UNITED STATES PATENT AND TRADEMARK OFFICE

APPLICATION NO.	FILING DATE	FIRST NAMED INVENTOR	ATTORNEY DOCKET NO.	CONFIRMATION NO.
10/600,065	06/20/2003	Ming-Huei Shieh	AF01169/AMDP975US	5651
23623	7590	04/04/2006	EXAMINER	
AMIN & TUROCY, LLP 1900 EAST 9TH STREET, NATIONAL CITY CENTER 24TH FLOOR, CLEVELAND, OH 44114			NGUYEN, DANG T	
			ART UNIT	PAPER NUMBER
			2824

Office Action Summary

FIGURE 3

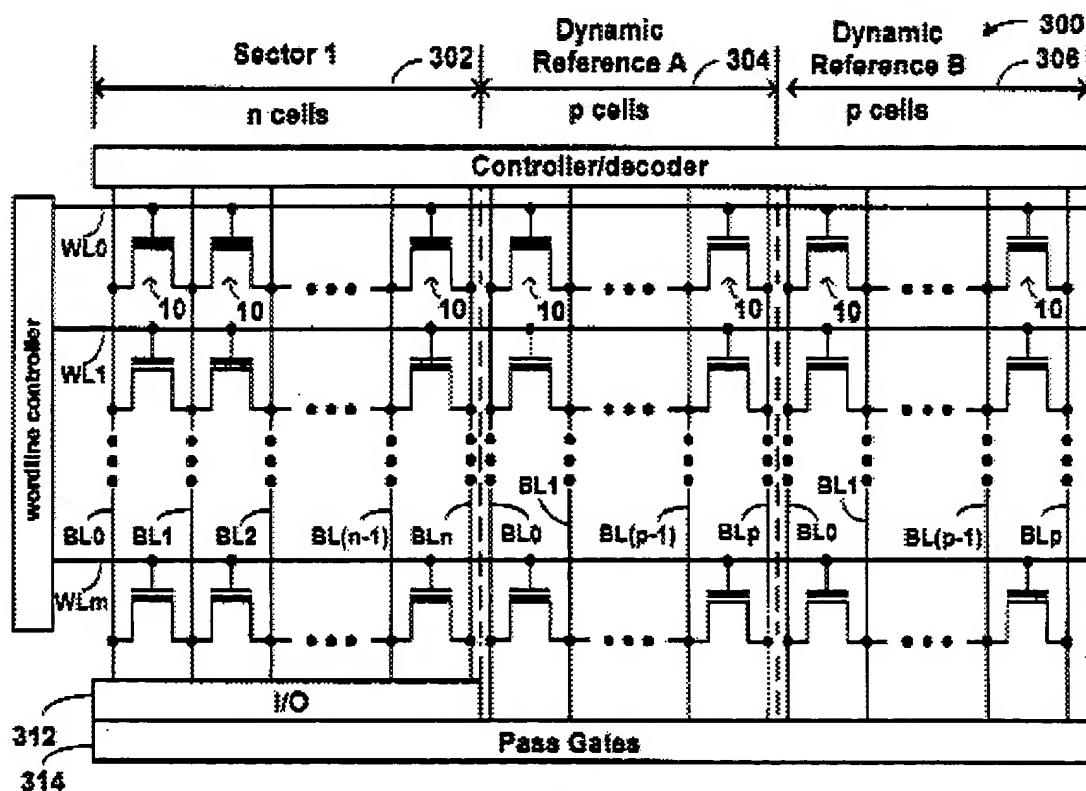
Regarding independent claim 1, Fig. 3 of Lee et al. discloses an architecture that facilitates a reference voltage in a multi-bit memory [302], comprising: a multi-bit memory core [302] including a plurality of data cells [10] for storing data; first and second reference arrays [Dynamic Reference A, Dynamic Reference B] of a plurality of multi-bit reference cells [10's of Reference A, 10's of Reference B] (Col. 5 lines line 45), the first and second reference arrays [Reference A and Reference B] fabricated on the memory core (Fig. 3 [302]), the plurality of multi-bit reference cells [10's] each associated with separate wordlines [WL0 – WLM] within the multi-bit memory core (Col. 5 lines 44-50); and a first bit value of a first reference cell (Fig. 4 [414]) of the first reference array (Fig. 4 [Ref A]) averaged with a second bit value of a second reference cell (Fig. 4 [418]) of the second reference array (Fig. 4 [Ref B]) to arrive at the reference voltage (Fig. 4 $(A+B)/2$) employed during a data cell read operation (Col. 4, lines 15 – 17).

Regarding dependent claims 2 and 18, Fig. 3 of Le et al. discloses that the core further comprise a sector [Sector 1] of multi-bit data cells [10] organized in rows and columns with associated word lines [WLs] attached to the multi-bit data cells [10] in a row and with associated bit lines [BLs] attached to the multi-bit data cells [10] in a column, the first and second reference cells [304, 306] forming a multi-bit reference pair (Fig. 4) that is programmed and erased with the multi-bit data cells [10] during programming and erase cycles (Col. 6 lines 7 - 21).

Regarding dependent claims 3 and 19, Fig. 3 of Le et al. discloses that the multi-bit reference pair [304, 306] is associated with a word in a word line [WL0], the multi-bit reference pair utilized during reading of bits of the word (Col. 4 lines 15 - 17).

Regarding dependent claims 4 and 20, Fig. 3 of Le et al. discloses that the multi-bit reference pair [304, 306] is associated with multi-bit data cells [10s] in a wordline [WL0], the multi-bit reference pair [304, 306] is utilized during reading of bits in the wordline (Col. 4 lines 15 – 17).

Fig. 3 of Le et al. discloses a plurality of multi-bit reference cells [cell 10s of Reference A and Reference B] each associated with separate wordlines WL0, WL1 to WLM within the multi-bit memory core (see Col. 5 lines 44-50); and

FIGURE 4

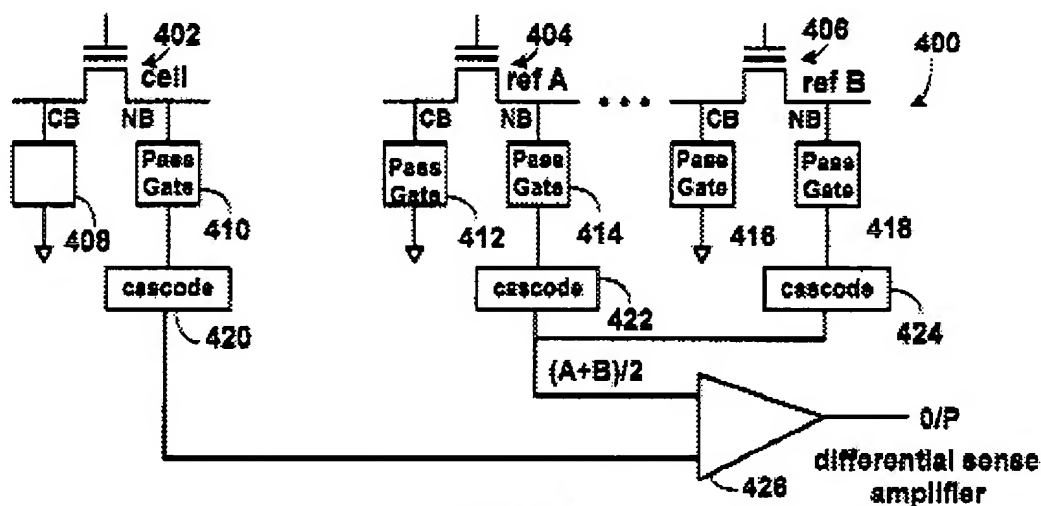
Fig. 4 of Le et al. clearly discloses a first bit value [414] of a first reference cell [404] of the first reference array [ref A] averaged $[(A+B)/2]$ with a second bit value [418] of a second reference cell [406] of the second reference array [ref B]. It is noted that Fig. 3 of Le et al. depicts the same structural configuration of the multi-bit memory core as that shown in Fig. 9 of the application.
